APPLICATION FOR SUBMITTAL OF POST-APPROVAL DOCUMENT

2. PROJECT INFORMATION:			
School District/Owner: Lodi Unified School District		DSA File Number: 39 H4	
Project Name/School: Lodi High School Breezeway Repair		DSA Application Number 02 121377

CCD NO. 01 NARRATIVE

School District/Owner: **Lodi Unified School District**
Project Name/School: **Lodi High School**
DSA File/Appl No.: **39-H4 /02-121377**
CCD Number: **#01**

1* = 1'-0" **3**

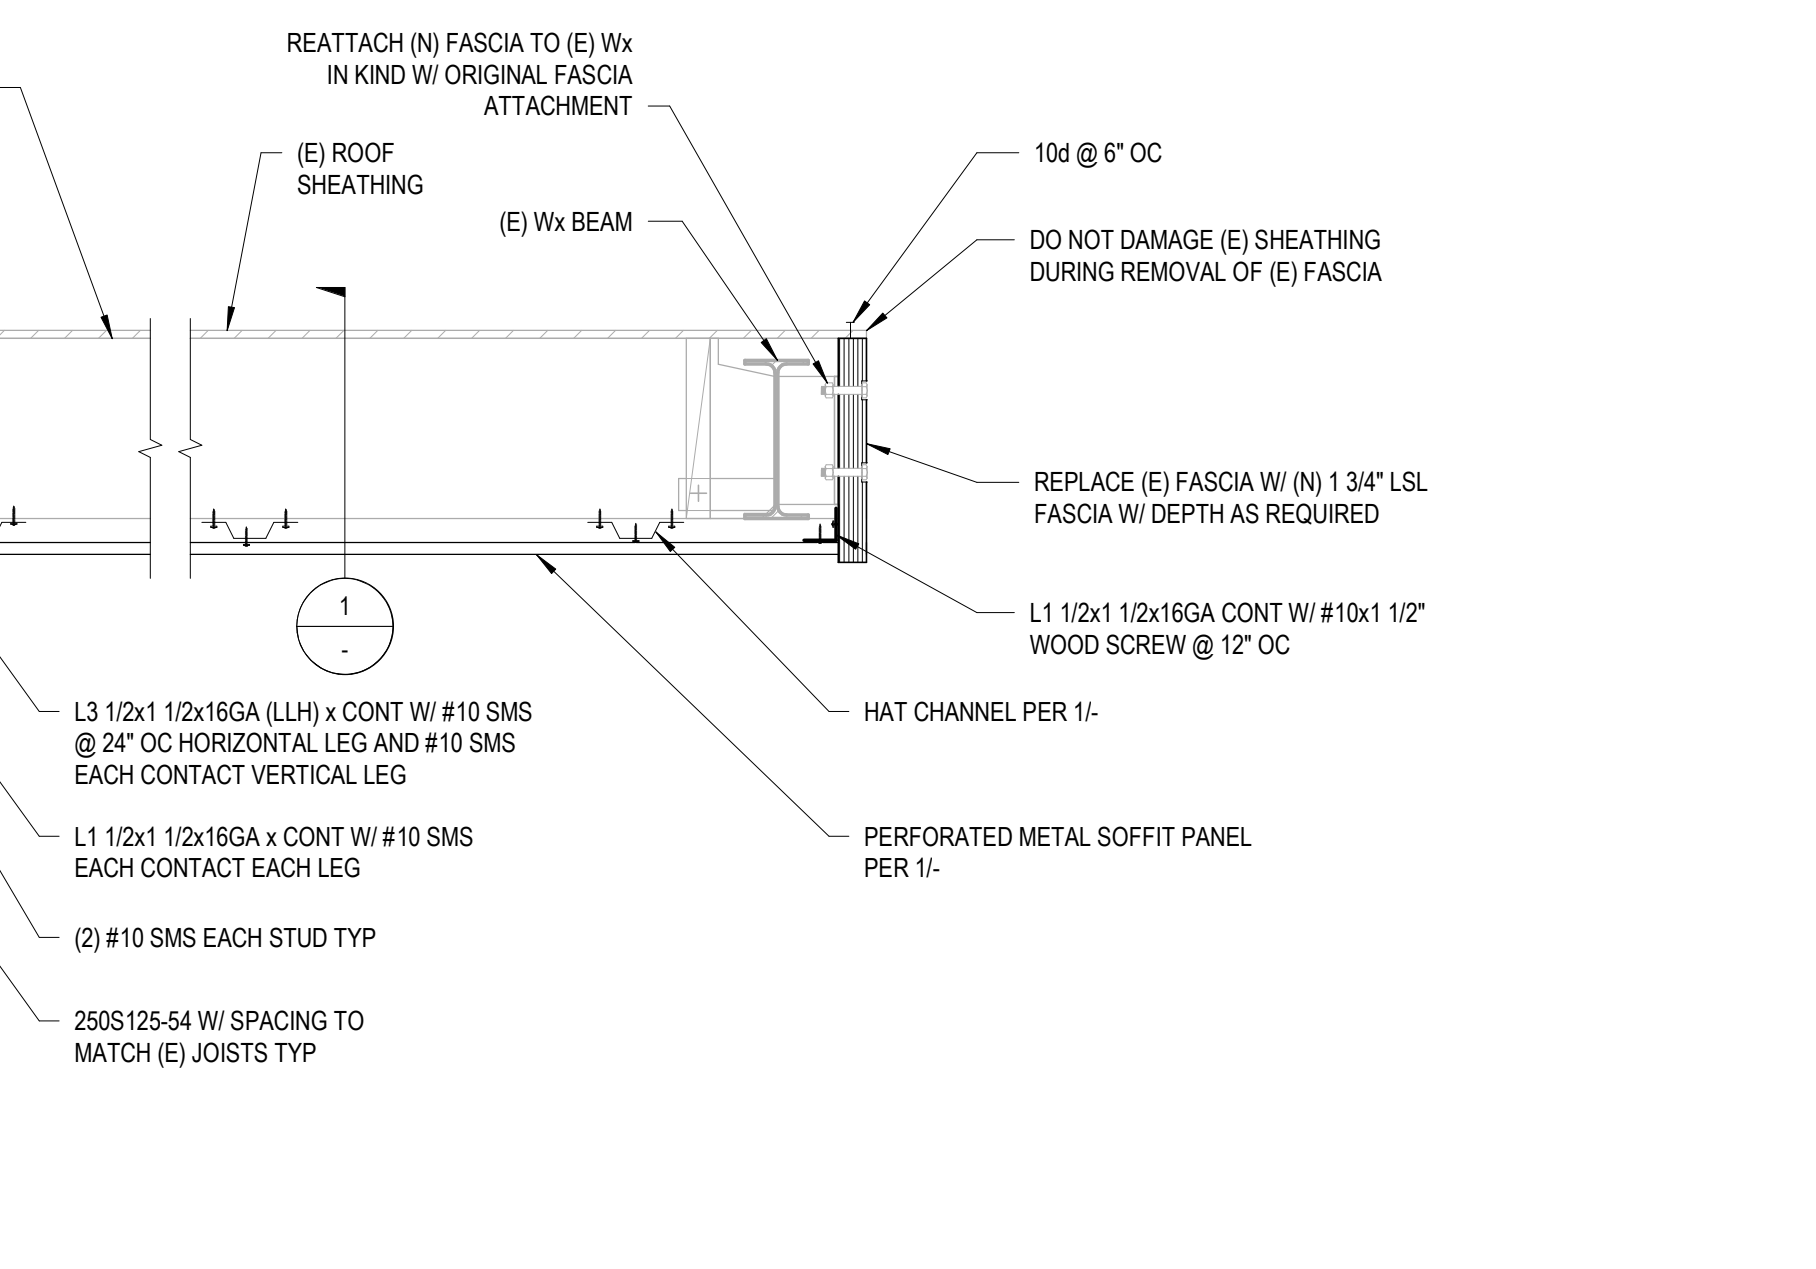
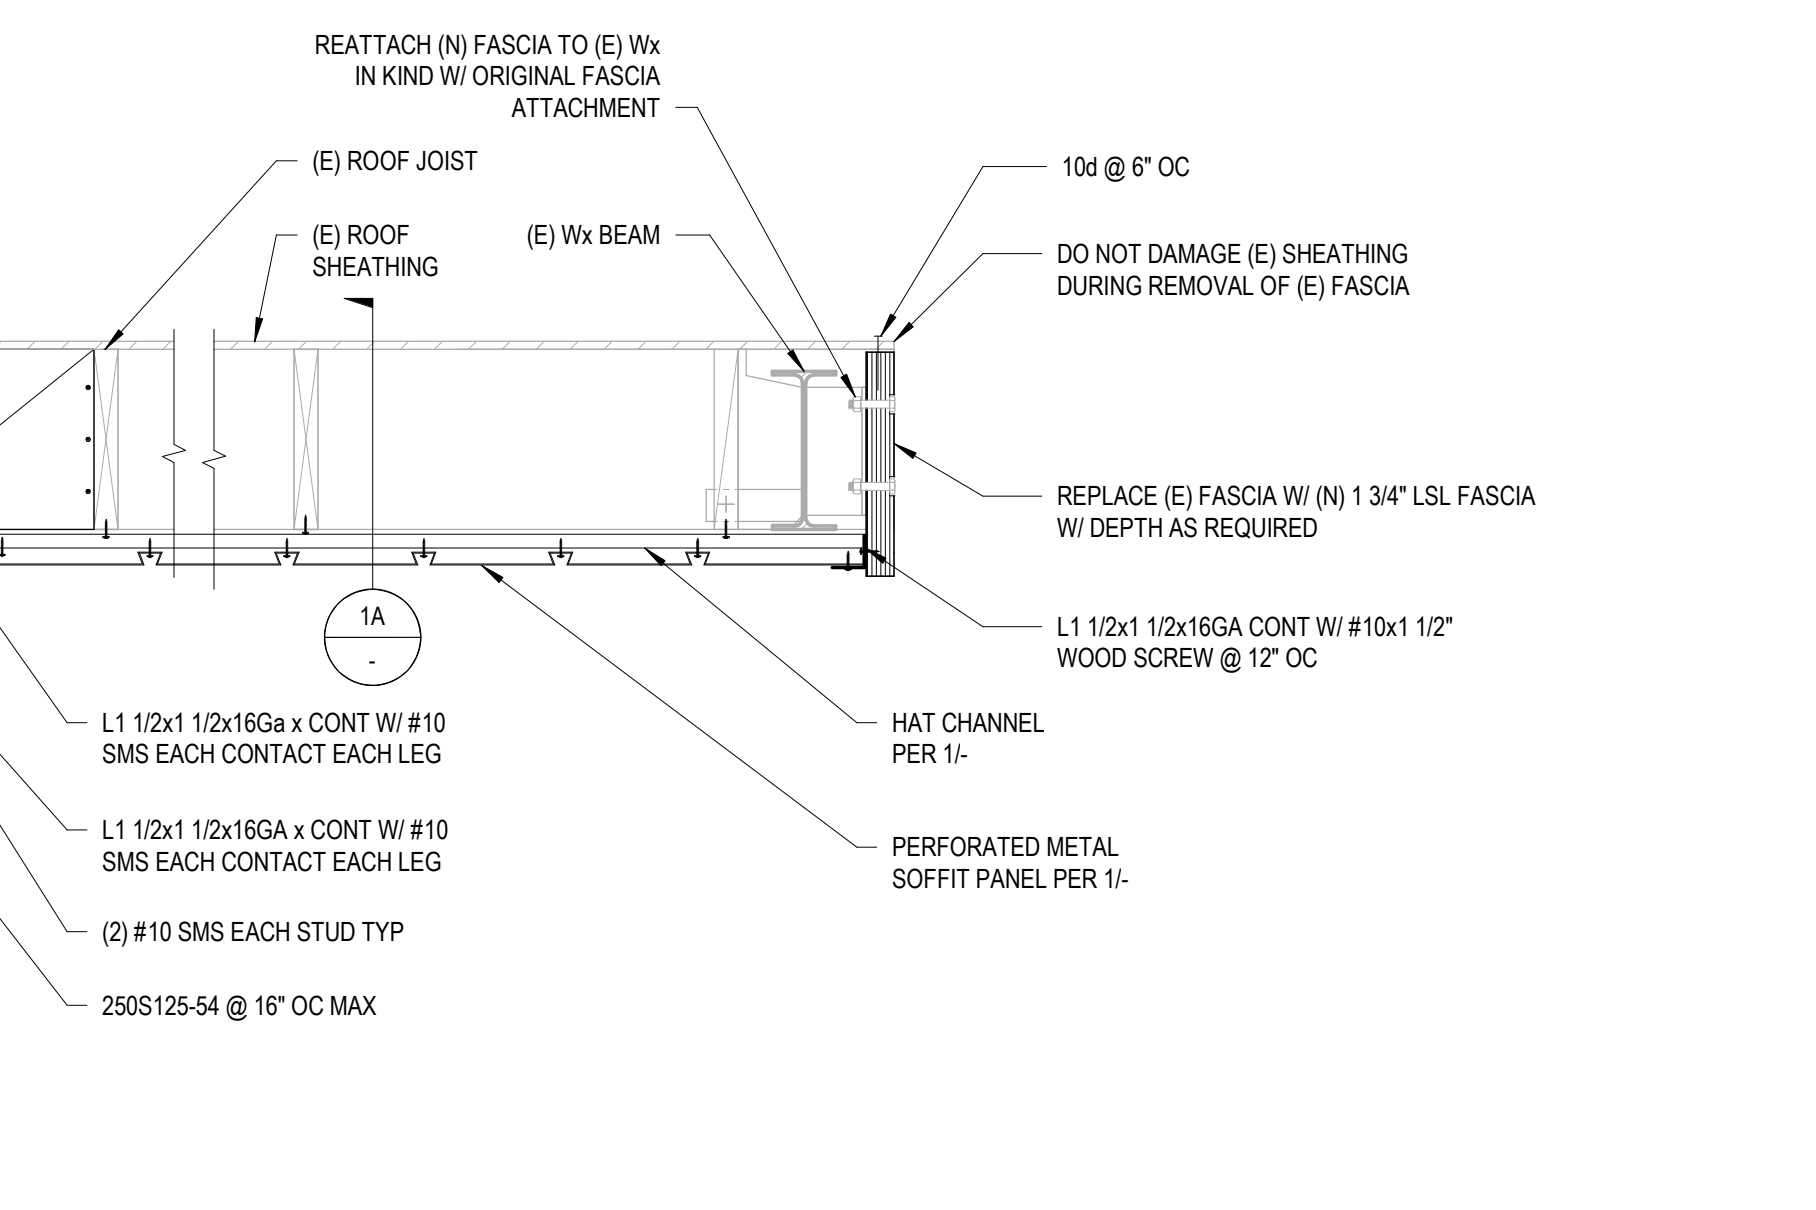
Details on sheet S2.1 have been revised to reflect new non-structural framing required to support an air barrier above windows. Additionally, sketches SK-01 – SK-06 have been included to show new support framing required for the currently unsupported section of plaster at the interior edge of the existing window systems.

CEILING TO OVERHEAD JOIST CONNECTION - PARALLEL JOISTS

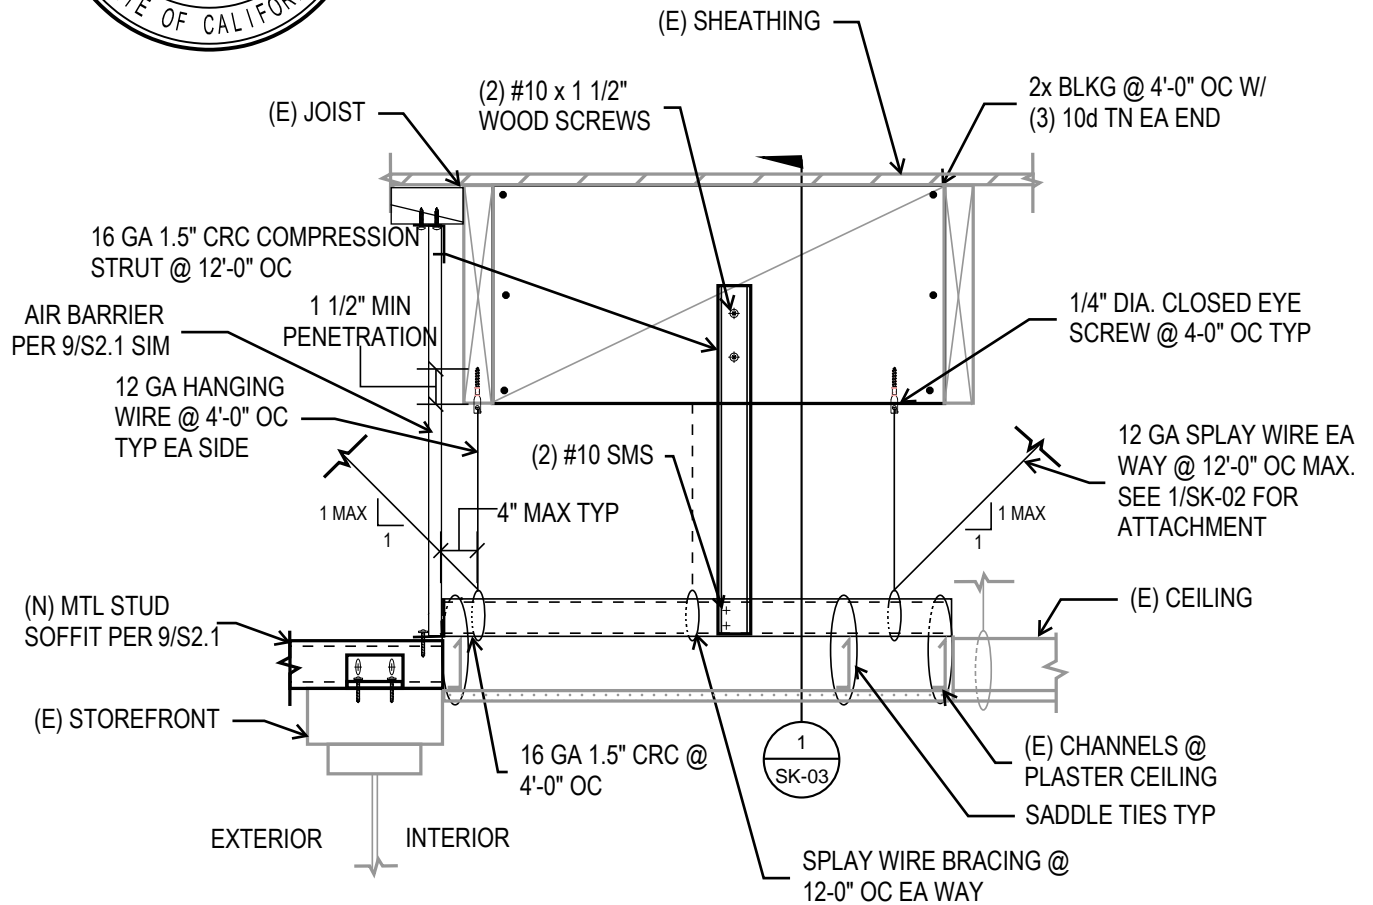
CCD	REF.		
DWG #	DWG #	DRAWING NAME	Calculation Reference
S2.1		S2.1 -	
SK-1	S2.1	Ceiling to Overhead Joist Connection-Parallel Joists	CCD 01 CALCS V2
SK-2		Lateral Brace Attachment to Blkg	CCD 01 CALCS V2
SK-3		Compression Brace to Blkg	CCD 01 CALCS V2
SK-4		Lateral Brace to Blkg - Perpendicular	CCD 01 CALCS V2
SK-5	S2.1	Ceiling to Overhead Joist Connection-Perp Joists	CCD 01 CALCS V2
SK-6	S2.1	Ceiling to Overhead Joist Connection-Double Angles	CCD 01 CALCS V2
CCD01 Calcs
